**GE Monogram**

## Service Bulletin

GE MONOGRAM REFRIGERATORS REF 14-00 ZICS36N MODELS BUILT SINCE 1998 WAVY FRESH FOOD STAINLESS STEEL DOOR PANEL (OIL CANNING) PANEL SPACER KIT WR49X10023

**AUGUST 2000**

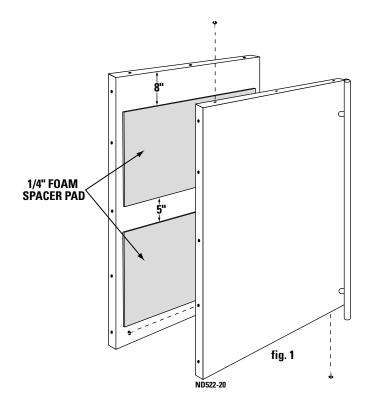
On some early GE Monogram bottom mount stainless steel models (ZICS36N) RH & LH the fresh food door panel may be wavy. Use panel spacer kit WR49X10023 to eliminate this problem.

- 1. Remove paper backing from the foam pads.
- 2. Using the dimensions from figure 1, position foam pads on the front of the fresh food door.
- 3. Press firmly against the foam pads for proper adhesion.
